Re: Mt. Polley Project - Tailings Storage Facility

Please find attached one copy of the Mt. Polley Tailings Storage Facility Construction Drawings and a corresponding drawing list. The drawings are being issued to support an Amendment to the Work Systems Application for the Mt. Polley Tailings Storage Facility. Some revisions have been made to the design since your last review. Some of the more significant revisions are summarized below:

TABLE 1

**MT. POLLEY PROJECT
CONSTRUCTION DRAWINGS**

SCALE AS SHOWN DRG. NO. 510-14-03-1625.212 REV. 1

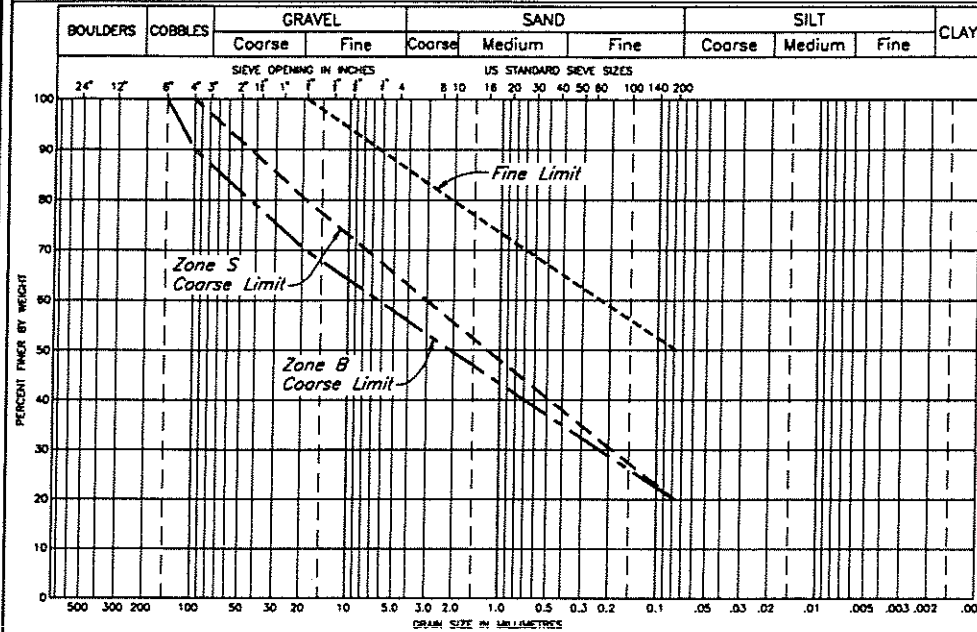
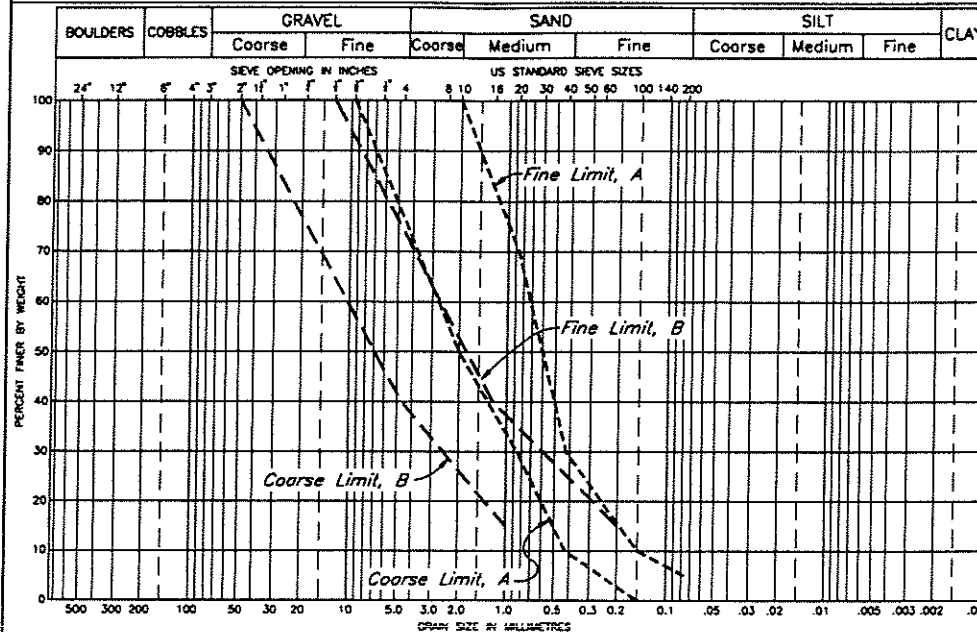
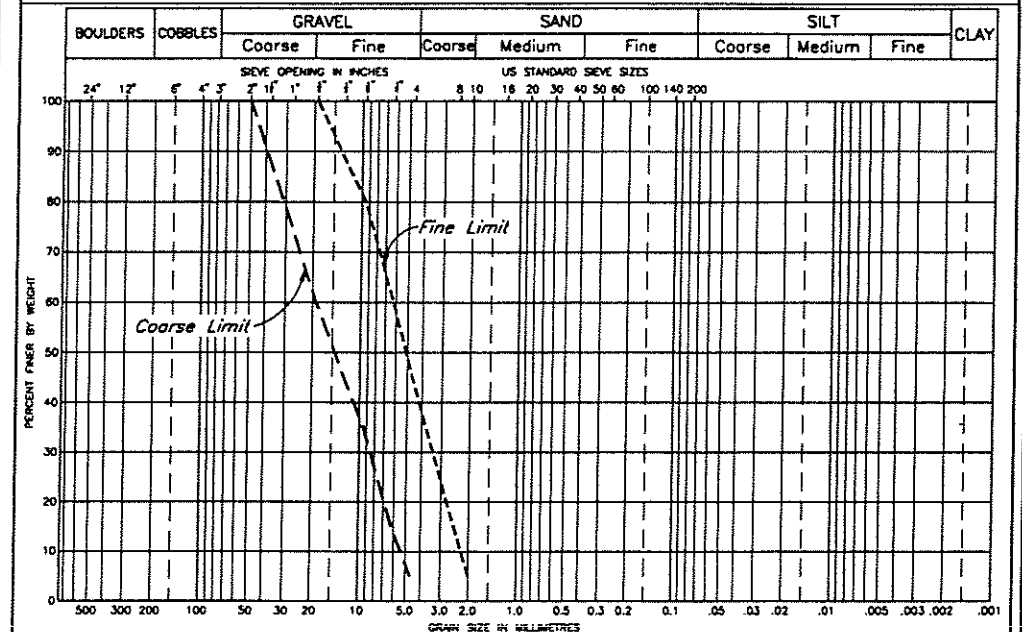
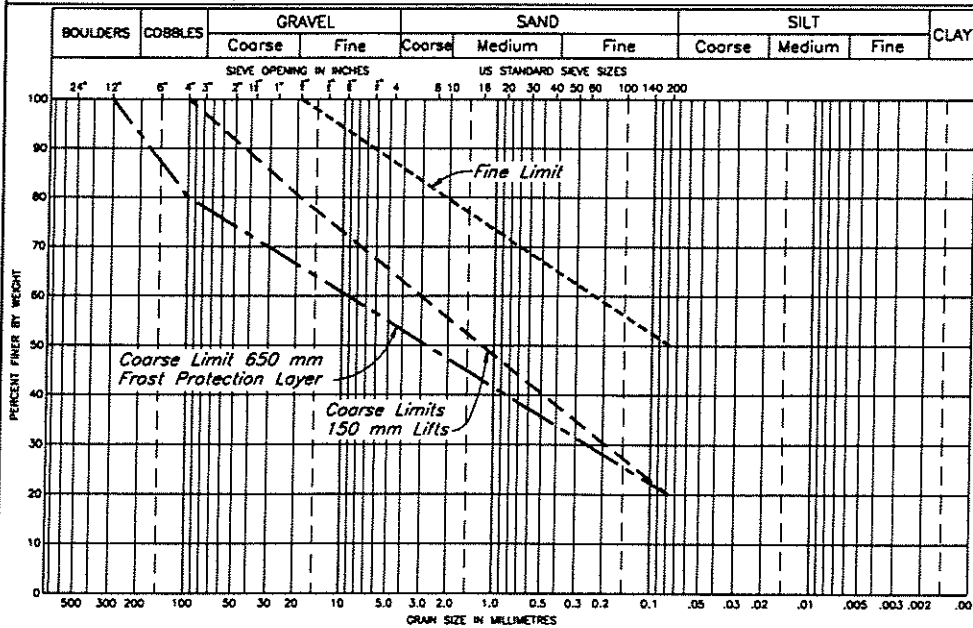
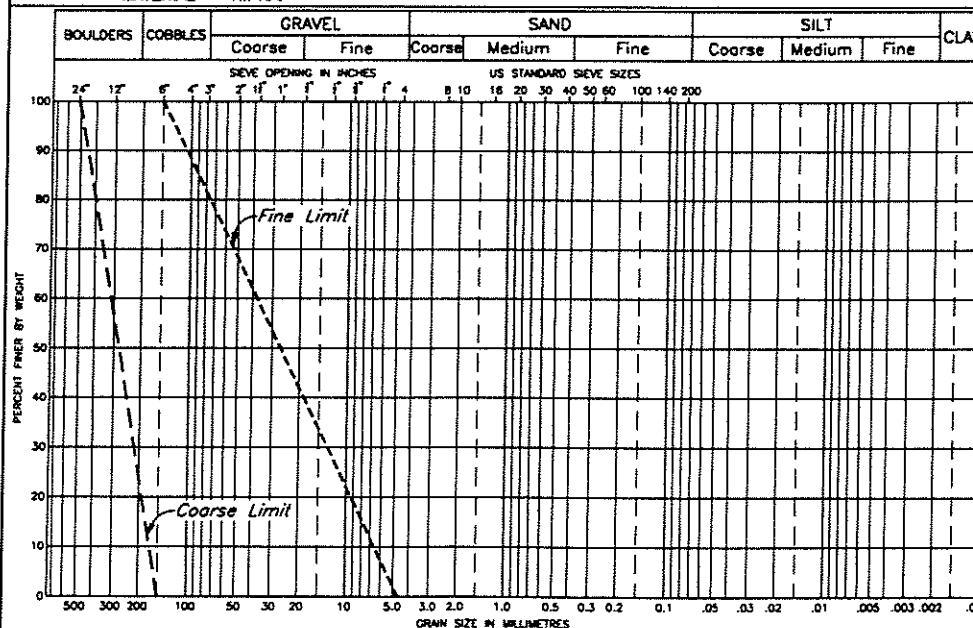
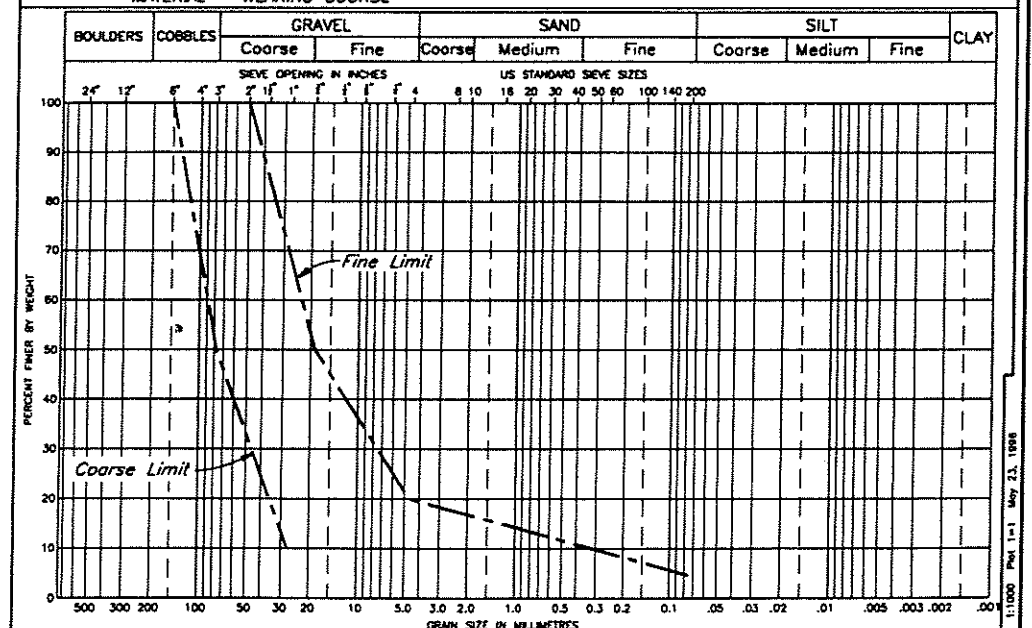
5. An alternate specification for the filter sand has been added (Material Type B), as shown on Dwg. No. 1625.212. The specification is taken from the

paper "Filters for Silts and Clays", by Sherard et al., which was published in the ASCE Journal of Geotechnical Engineering, Volume 110, No. GT6, June 1984.

DATE JUNE 2, 1995 SCALE AS SHOWN DRG. NO. 510-61-02-1625.219 REV. 5

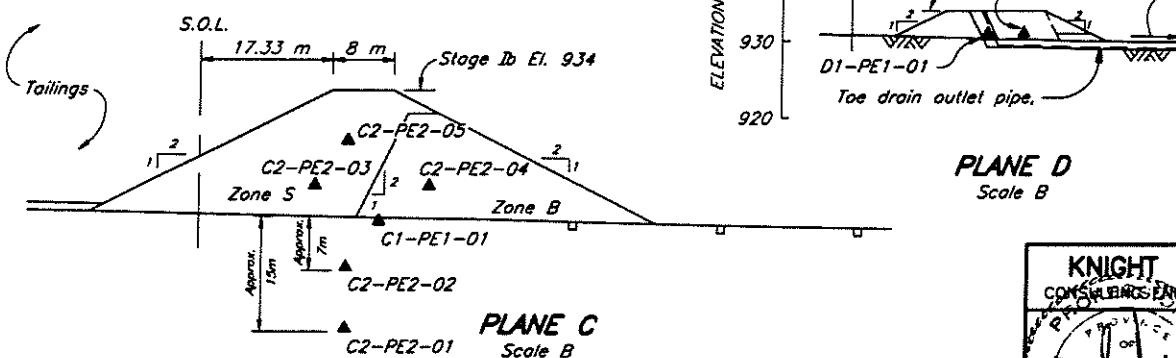
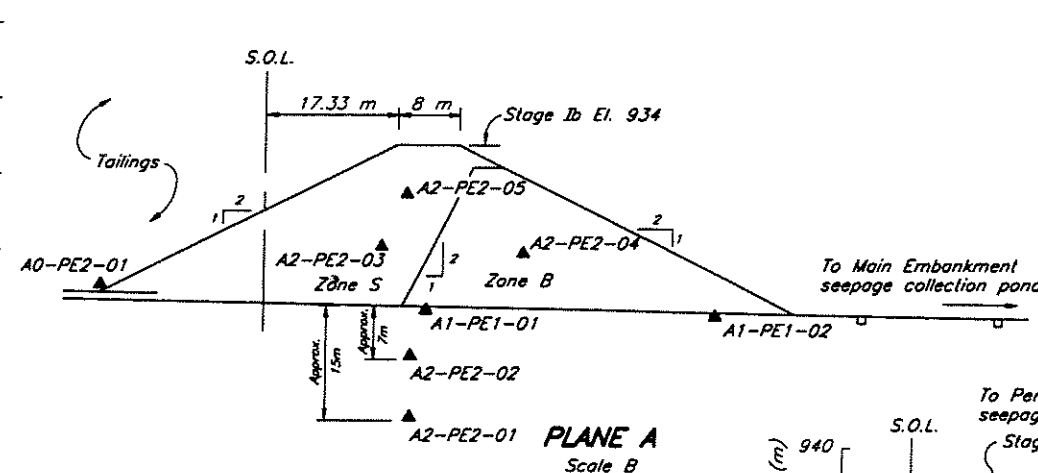
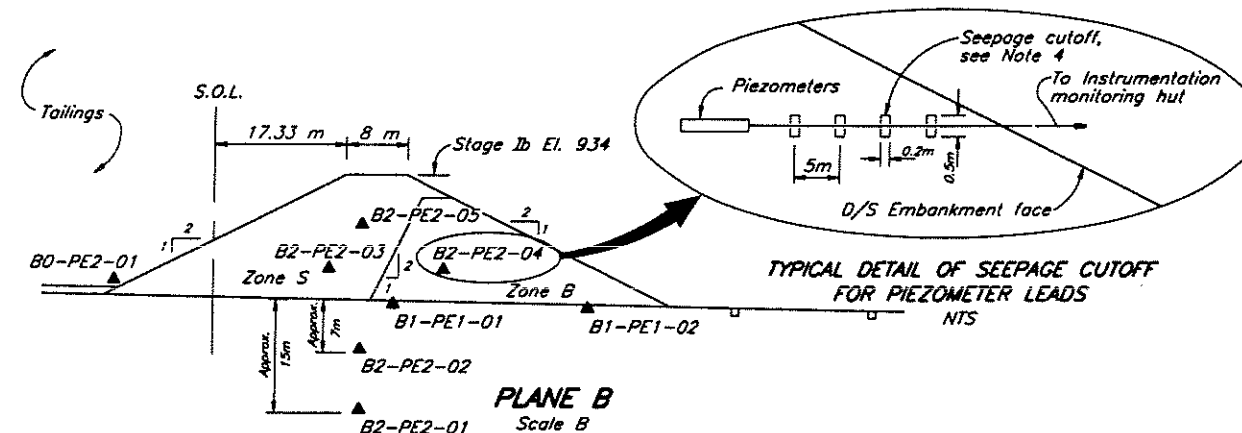
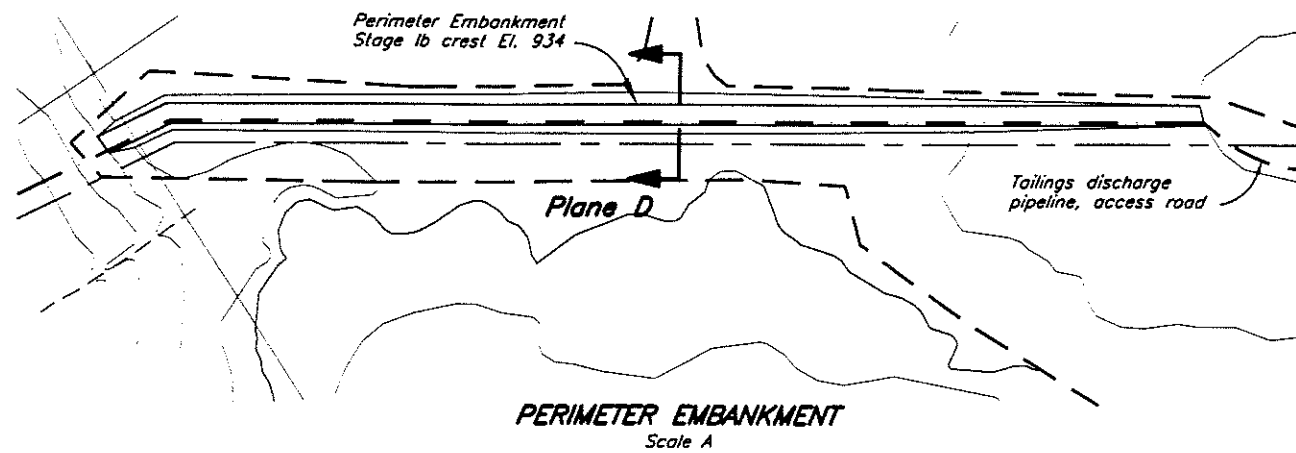
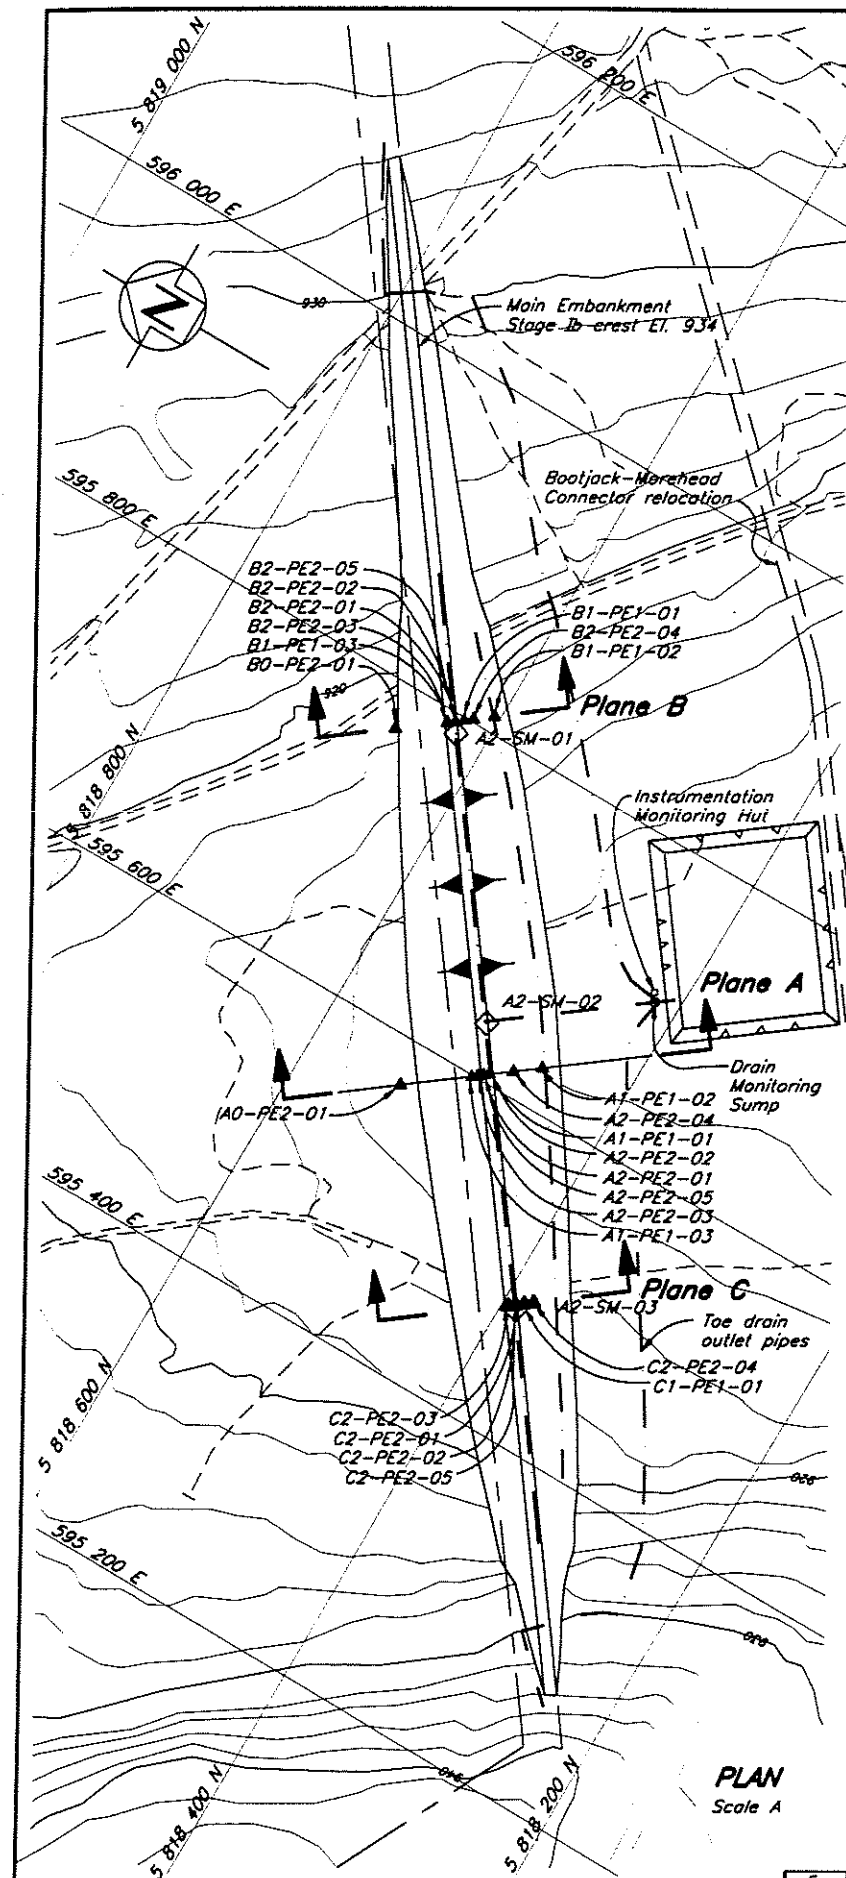
6. The tailings and reclaim lines are to be installed in pipe containment channels all the way from the mill to the tailings facility. The pipes are no longer buried up to the Bootjack Creek Crossing. This is shown on Dwg. No. 1625.219.
7. A separate runoff collection ditch has been added up gradient from the pipe containment channel on the road/pipeline cross section, also as shown on Dwg. No. 1625.219.
8. A fourth instrumentation plane, Plane D, has been added at the Perimeter Embankment, as shown on Dwg. Nos. 1625.220 and 1625.221.
